RE: Response to Assessment Report Ppty: Roseville Memorial Club – DA0134/18 | PPS-2018SNH040

Itemised Response to Planning Assessment Report dated 4 February 2020

Advice re 64-66 Pacific Hwy, development application DA0134/18

SCALE:	DRAWING NO:
1:100 @ A1 / 1:200 @A3	DV205
PROJECT NO:	DAIUZ
1732

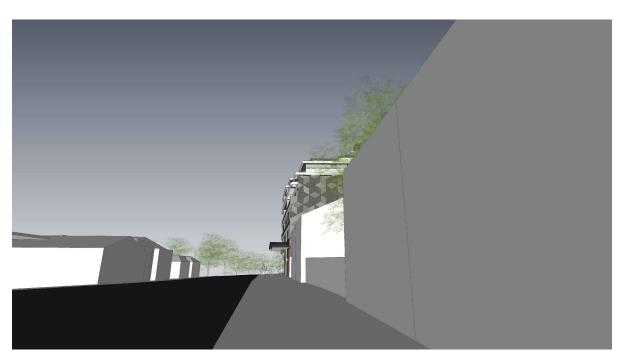
- In **Appendix 2** we have provided additional view angles prepared by PBD Architects identifying the appropriate design and low impact of the roof top terrace.

CIVIL DESIGN GROUND STORMWATER PLAN

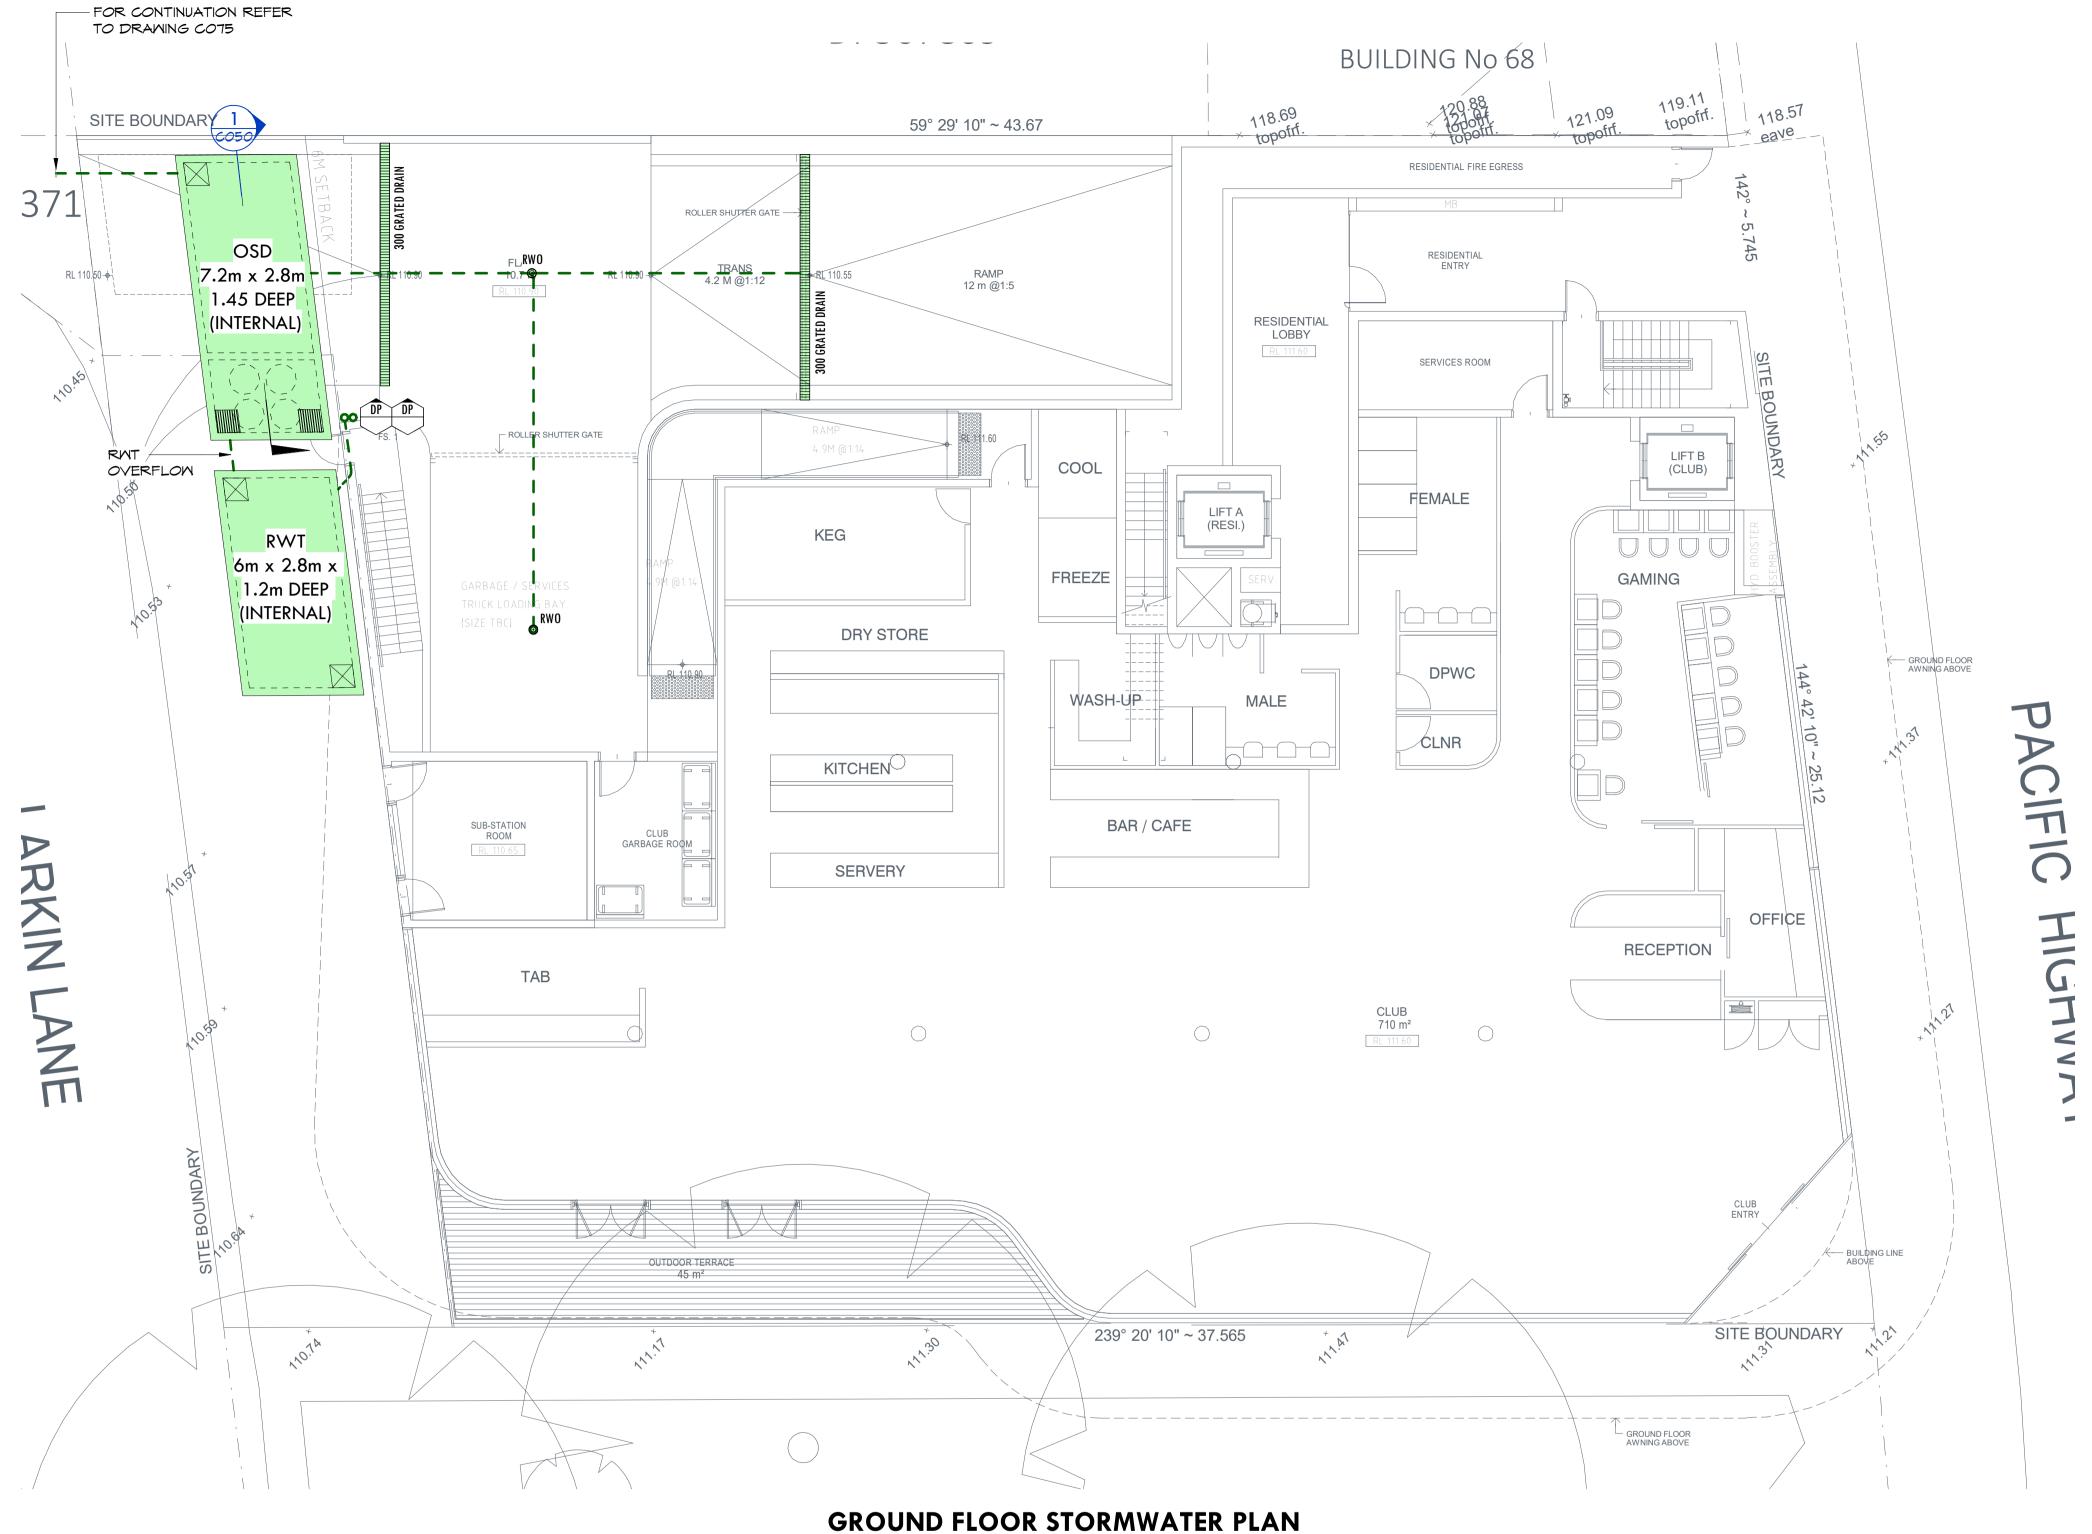
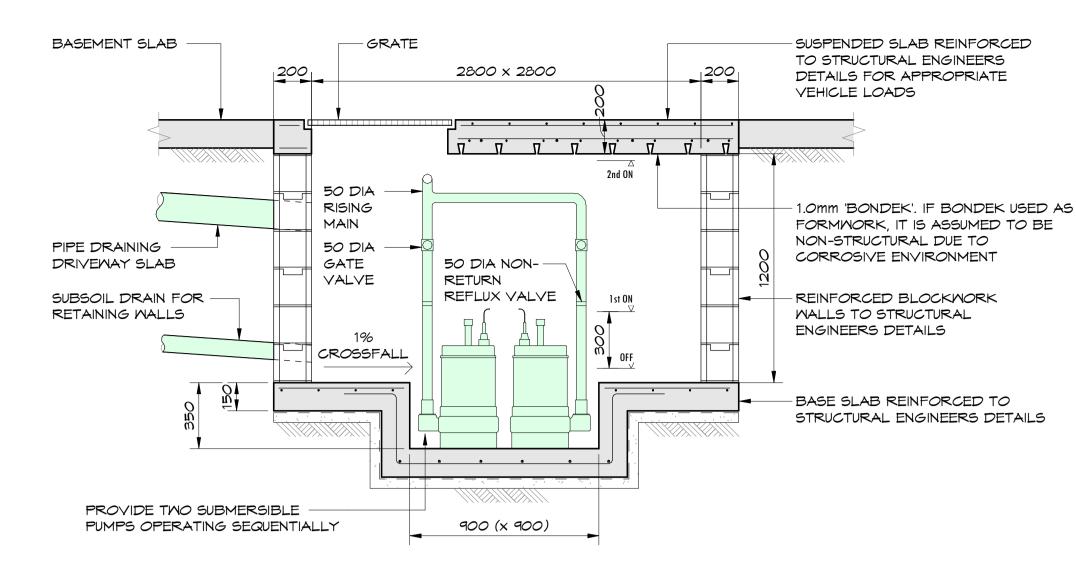
For the avoidance of doubt, in Appendix 7, we have included updated Stormwater plans with additional information now notated on the plans.
